## Addendum

ADDENDUM NO.: 2 DATE: 4/5/2021

PROJECT TITLE: Fretwell Café Renovations  
University of North Carolina Charlotte  
SCO ID# 19-21437-01A  
WTS Project No. 2007

1 FINISH FLOOR PLAN - LEVEL 1  
A7.01 1/4" = 1'-0"

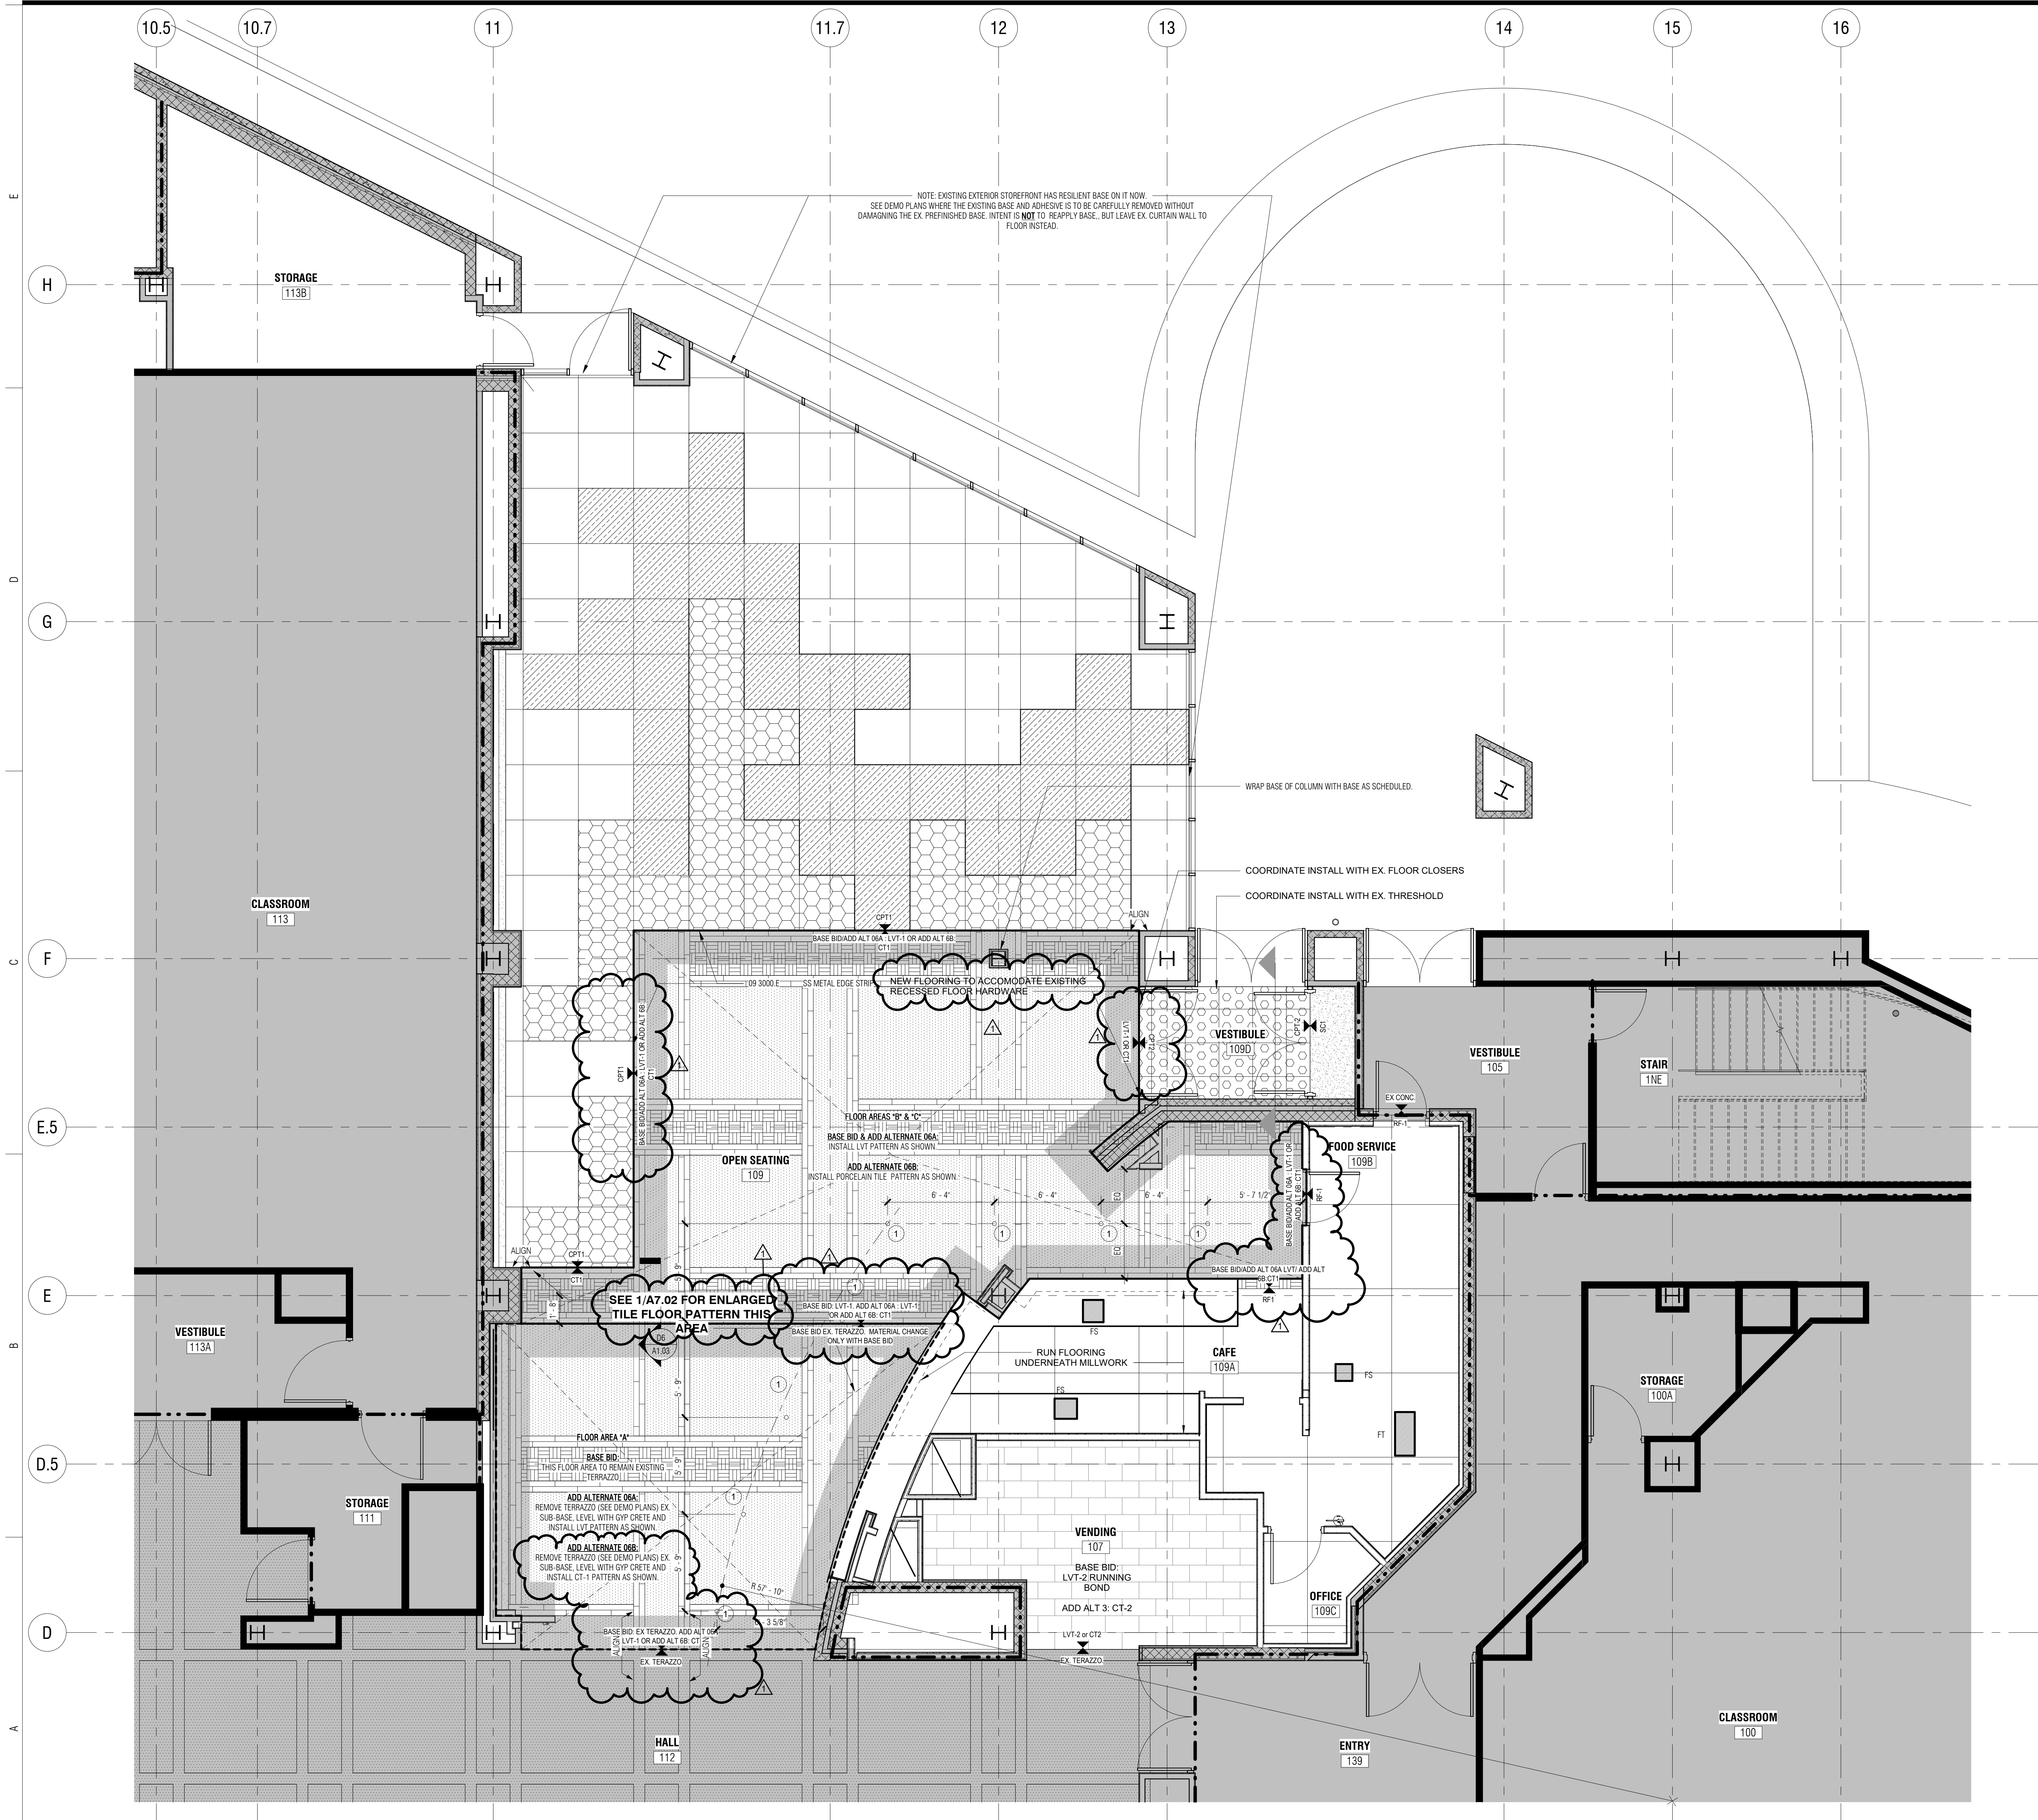
RFI#	RFI	RESPONSE
1	The spec book calls for the base bid to be LVT for Open Seating 109 areas B & C. The finish plan on A7.01 shows existing terrazzo, CFT1 and CFT2. What should it be?	The Project Manual’s description of Add Alternates is Correct. The A7.01 sheet issued with the bid documents has been updated to match. Base Bid is a combination of existing terrazzo with LVT. Add Alt 6a is LVT and Add Alt 6b is Porcelain tile.
2	The alternate descriptions for alternates 06A and 06B on Floor Area A on the finish plan show LVT pattern as shown. The alternates described in the spec book call for LVT for alternate 06A and CT-1 for alternate 06B. Which should it be?	The description of Add Alt 06B has been revised to CT-1.
3	Should the America Oak stripping for both sides of LVT-1 be used in all instances where it is used?	The intent of the stripping is to allow the band widths to equal 8 inches wide and align with the grid pattern of the existing terrazzo in both directions. So it should be used on 8” bands both sides 3/8” + 7 ¼” + 3/8” to align with 8” bands. Infill to be the small parquet. See Reissued Sheet A7.02 for further clarification.

4	On the finish schedule under the LVT-1 listing there is mentioned of a parquet “Infill”. Where is that applied?	In base bid and Add Alternate 06A, the parquet LVT is used in between the 8” strips. See Re-issued Sheet A7.02 For Further Clarification.
5	Regarding the finish key for CPT-1, are 1.1, 1.2 and 1.3 colors Nebula, Ultraviolet and Carbon Tile respectively?	This is correct.
6	Detail 1/A7.02 on the northeast corner when imported into the finish plan looks like it extends into the vestibule 109D. Is that correct?	The Vestibule is Walk-off Carpet. Detail 1/A/7.02 incorrectly shows LVT/CT going passed the door into the vestibule. It is correct on 1/A7.01, and will be corrected on 1/A7.02.
7	At column E on the finish plan there is a note referencing A3/A8.02 calling out a floor pattern. There is no floor pattern on that page. Should that be on 1/A7.02?	This Note should reference 1/A7.02, not A3/A8.02. Sheet A7.01 will be reissued with the change to this note.
